JC PENNY 6247
MIDLAND 79-892

TRUETONE MODEL CYJ-4837A-87 SLIDER

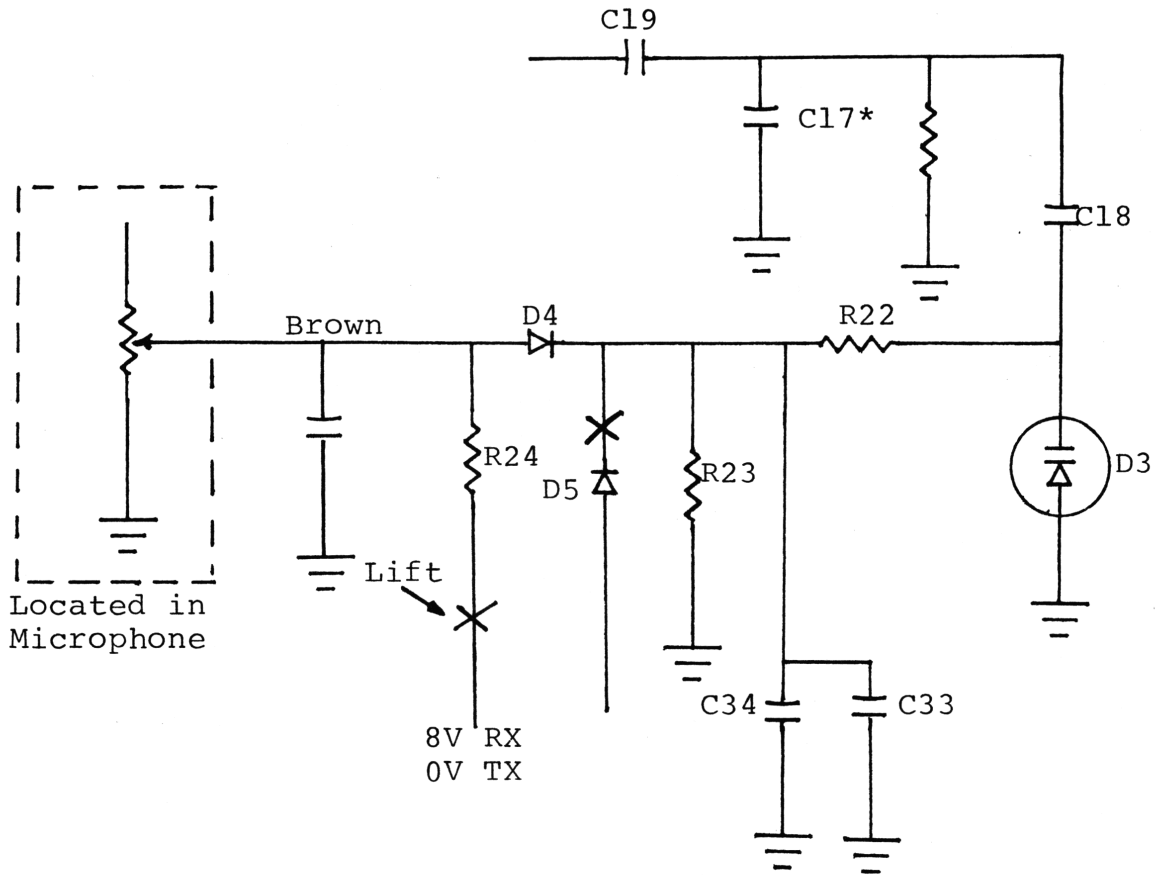
1. Lift R24 opposite D4.
2. Install new wire from lifted end of R24 to emitter of Q44.
3. Clip D5.
4. The value of C17 can be altered slightly for best slide? Didnt try this yet

5Kc total

2kc ↓

3kc ↑
